DESIGN REVIEW COMMISSION

4.a **continued from September 5, 2019** Design Review Request (DR19-03) by MMCG GOI Astoria LLC, to construct a 16,000 square foot Grocery Outlet structure at 2190 Marine Dr. in the LS (Local Service) Zone, GOZ (Gateway Overlay Zone), and CGO (Civic Greenway Overlay) Zones.

SUBJECT: DESIGN REVIEW REQUEST (DR19-03) BY MMCG GOI ASTORIA LLC TO
CONSTRUCT A COMMERCIAL RETAIL FACILITY AT 2190 MARINE DRIVE

RE: City of Astoria File No. DR19-03; Application by MMCG Astoria, LLC;
Applicant's Final Written Argument Without New Evidence

Proposed windows

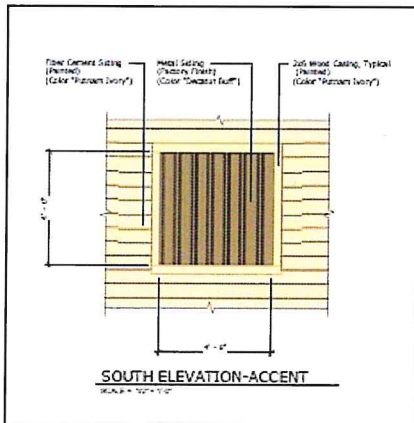
Finding: Proposed windows are clear, insulated low “E” glass; 2” x 4.5” aluminum, true divided, storefront window system. Windows are fixed. Windows will provide openings into the building. The applicant has indicated that the nature of the store will result in the windows being blocked by racks of boxes and products and will not provide clear view into the building. Windows would have a 2” x 4” wood casing. The north, east, and west elevations have multiple windows. The south elevation is the utilitarian side of the building and will be the cargo delivery loading area. This elevation would also be partially blocked by the adjacent mini-mart building and not as highly visible. The two ends of the elevation will be visible, and the applicant has proposed two design features in that area of vertical corrugated metal siding. The main entry doors are visible in the tower feature.

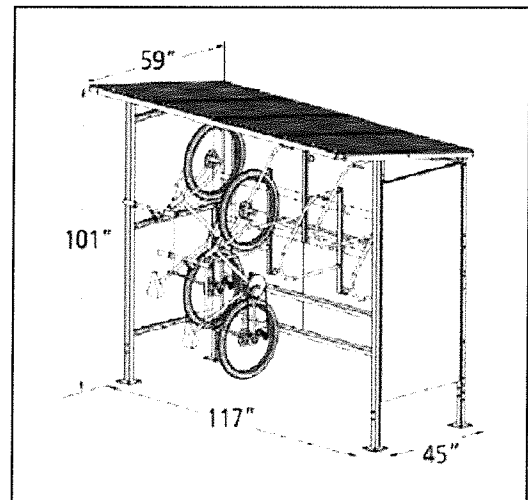
The bicycle storage area is proposed to be a three-sided enclosure for 4 to 6 bicycles; option of polycarbonate wall panels either galvanized or powder coated; option of either polycarbonate or galvanized S deck roof. The exact design of the storage area to meet the requirements of Development Code Section 7.105 will be reviewed by the Planner and is not part of the Design Review Commission review. However, the location and materials are part of the DRC review.

Polycarbonate is a thermoplastic polymer and is not one of the "encouraged" wall treatments. The option for a galvanized or powder coated metal would be similar to the vertical corrugated metal siding on the main building. The bicycle storage area shall have siding to match the main structure to be reviewed and approved by the Planner (Condition 2).

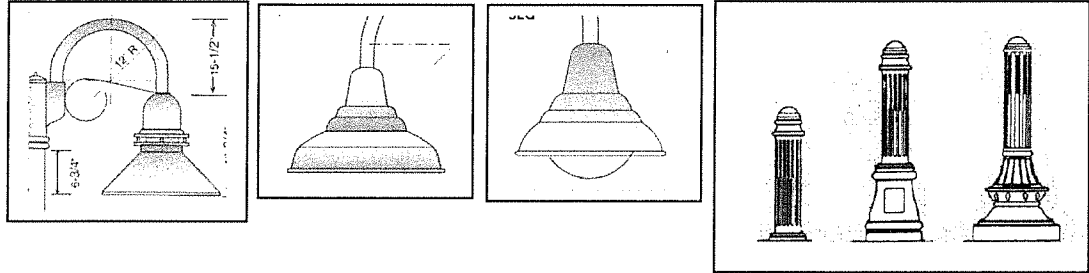
Finding: The roofing material proposed would be white TPO membrane over rigid insulation over metal deck. The bicycle storage area is proposed to have either polycarbonate or galvanized S deck roof. Polycarbonate is a thermoplastic polymer and is not one of the "encouraged" roofing material. The option for a galvanized metal roof would be similar to the vertical corrugated metal siding on the main building. The bicycle storage area shall have roof of metal or other approved material to match the main structure to be reviewed and approved by the Planner (Condition 3).

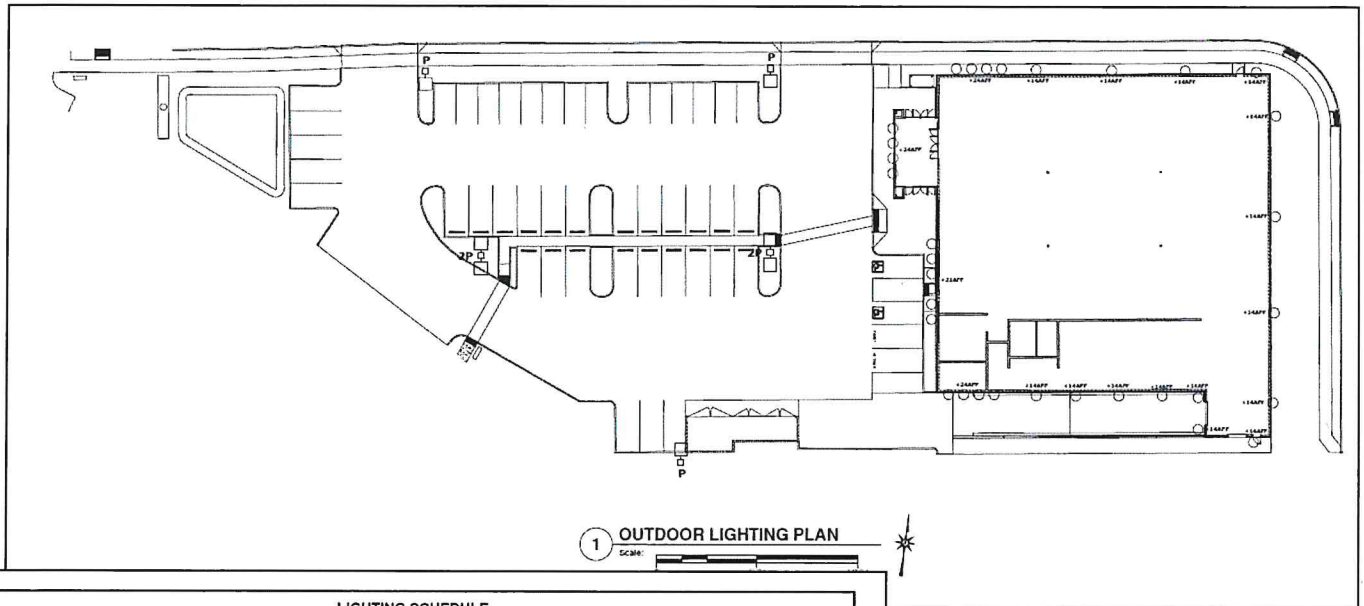
The location of the parking lot light poles will need to be verified as the lighting plan appears to show the poles located outside the applicant's property lines. The pole on the south elevation near the solid waste disposal enclosure and three parking spaces is on the adjacent property and should be moved to the west to within the property lines. The two light poles on the north property line appear to be located within the Commercial Street right-of-way. These should be moved to be within the property lines (Condition 4).

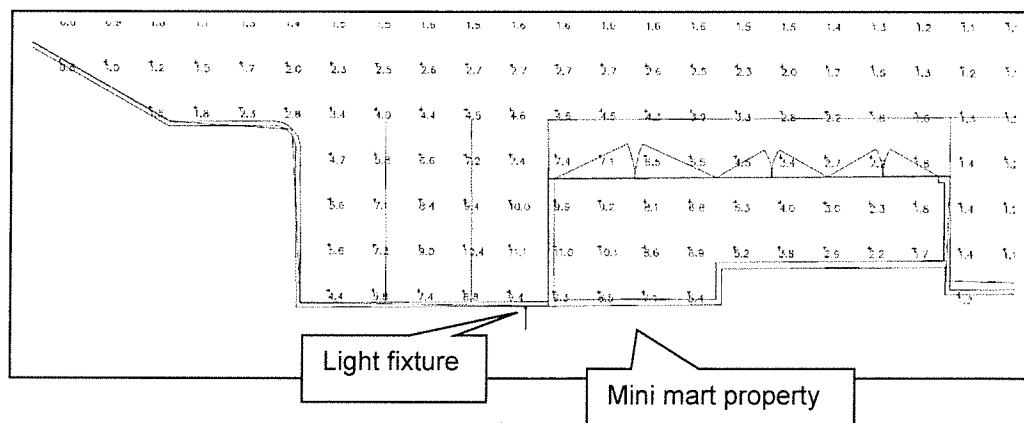
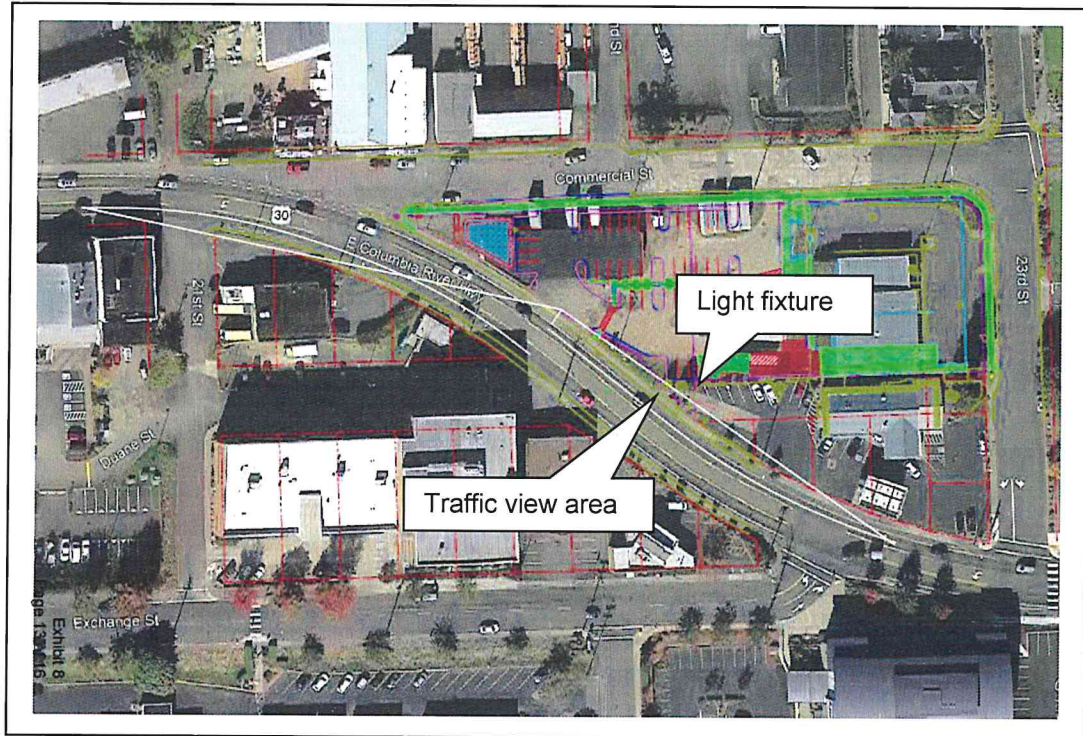
The photometric calculations for the delivery ramp on the south elevation are also extremely bright and will draw even more attention to the elevation that does not have windows. The footcandles in this area range from 9.9 fc to 12.5 fc on the east end and from 5.8 fc to 13.1 fc on the west end. If the brighter lights are needed for safe deliveries, a revised lighting design may be required. The proposed lighting along the south elevation at the delivery area shall be either reduced in number and/or footcandles to reduce glare, or limited in use at times other than during deliveries to just provide security while not glaring brightly at any time (Condition 6).

The photometric calculations along the south property line at the solid waste disposal area with a parking lot pole light ranges from 4.4 to 9.4 at the property line. This is the view area for traffic turning into the site as noted in the TIS Technical Memorandum, dated August 23, 2019, provided by the applicant in response to Greenlight Engineering Analysis Letter. This could create glare into the right-of-way that could be a safety issue. As noted above (Condition 4), the light pole should be moved more to the west which will cause the intense light to encroach even more into the traffic view. The photometric calculations do not show the amount of light that will trespass onto the adjacent property (mini mart).

The number and intensity of the lighting in some areas as noted above do not meet the criteria of preventing light from glaring into adjacent properties and/or rights-of-way. A revised lighting plan shall be submitted for review and approval of the Planner prior to issuance of the building permit that reduces the glare trespass into adjacent properties and rights-of-way (Condition 7).

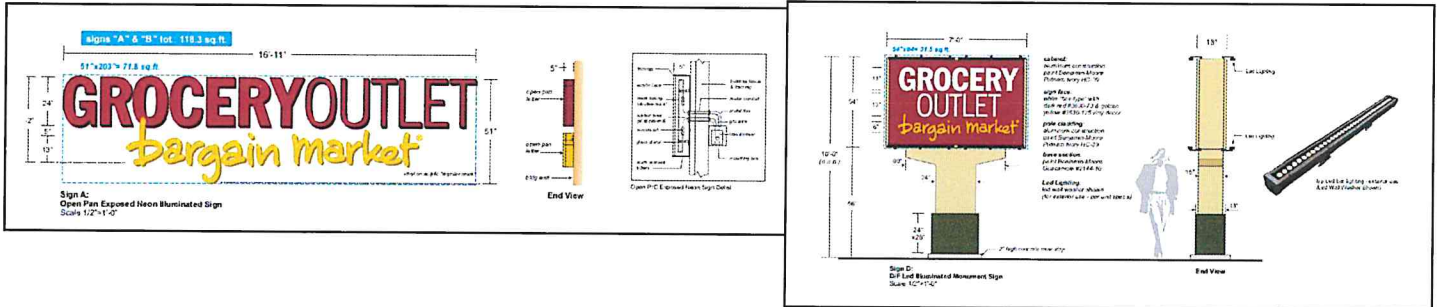
Finding: Signage is proposed on the east and west elevations with a monument sign on the northwest corner of the lot. Wall signs are proposed to be neon channel lettering with a clear acrylic cover for protection. The monument sign would have external lighting. This portion of the criteria is met.

The monument sign proposed by the applicant had a narrow base. The code discourages “pole mounted freestanding signs”. Freestanding signs are defined as “supported by one or more upright poles, or other support structure”. When the code was written, the term “pole mounted” freestanding sign was used to differentiate it from other “freestanding signs” such as sandwich boards. However, the code is not specific. At the public hearing on August 1, 2019, a comment was made that the proposed sign was not a “monument” sign as the entire bottom of the sign was not in contact with the ground. The applicant submitted a revised sign design that fully meets the definition of a monument sign. With the 10’ height of the sign, this full base creates a much larger structure. The DRC should decide if the original design meets the requirements of an allowable sign for this area or if the full base is required. The final location of the sign will need to be reviewed and approved by the City Engineer for vision clearance at an intersection (Condition 8).

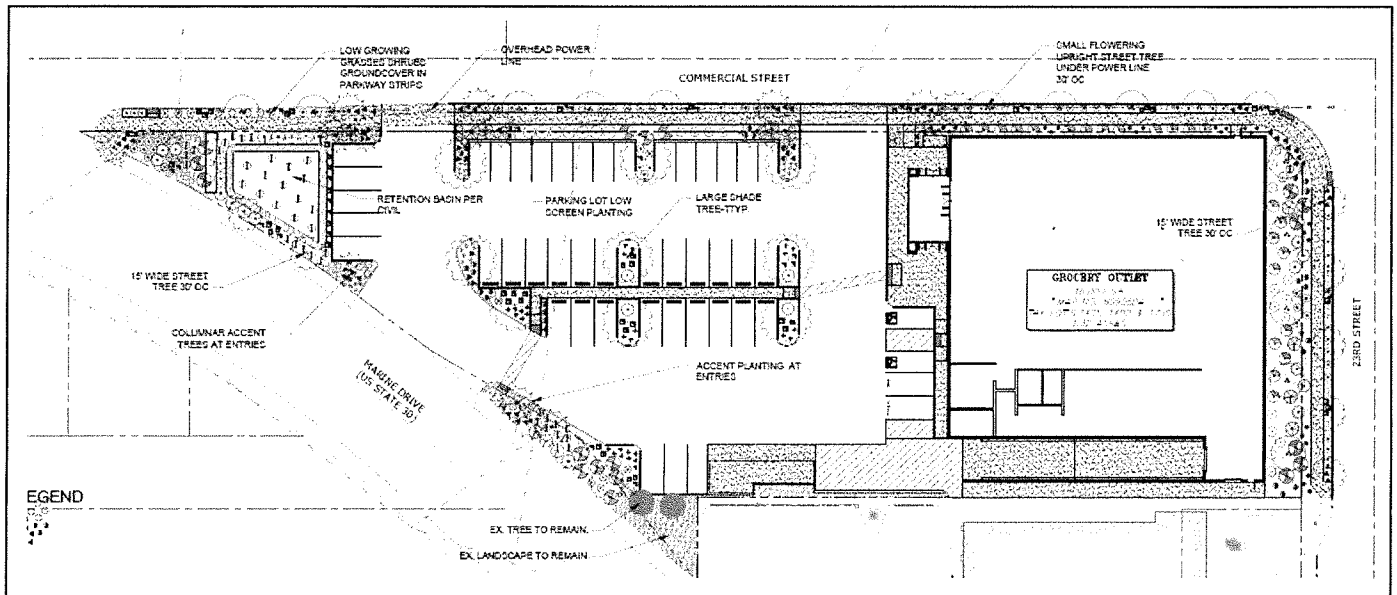
Finding: The applicant has submitted a landscape plan that indicates landscaped areas on the site plan with on-site and landscaping within the right-of-way for a total of 11,936 square feet. The site is approximately 57,500 square feet and 20% landscaping would be 11,500 square feet. The plants indicated on the plan are mostly native plants. However, staff will review the list in detail to confirm the various species proposed are acceptable for this area. One issue staff will review is that trees adjacent to public walkways should not be fruit bearing trees to avoid fruit dropping on the sidewalks requiring clean up and possibly causing unsafe walking conditions. Landscaping shall be installed prior to occupancy of the building (Condition 16).

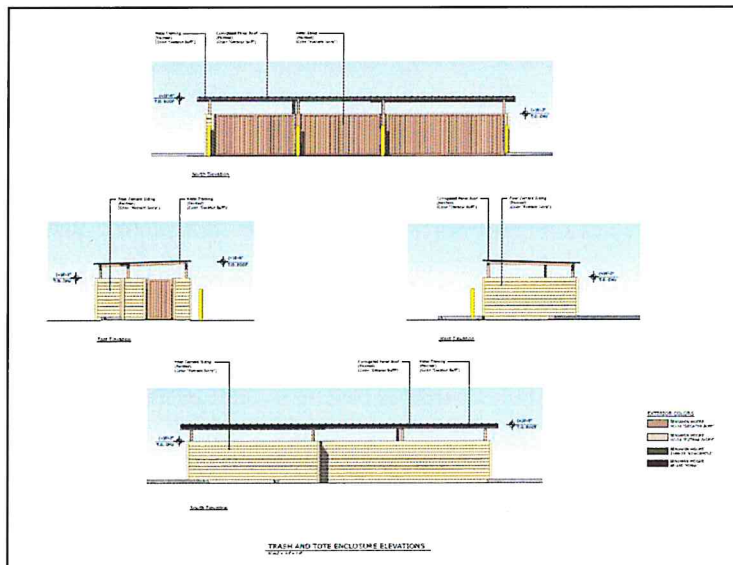
Finding: The proposed solid waste disposal area is approximately 771 square feet (approximate 19' x 44'); 6.2' tall with a corrugated metal roof over the full structure at 7' tall. The structure is proposed to be smooth, horizontal fiber cement siding with metal cargo and person doors.
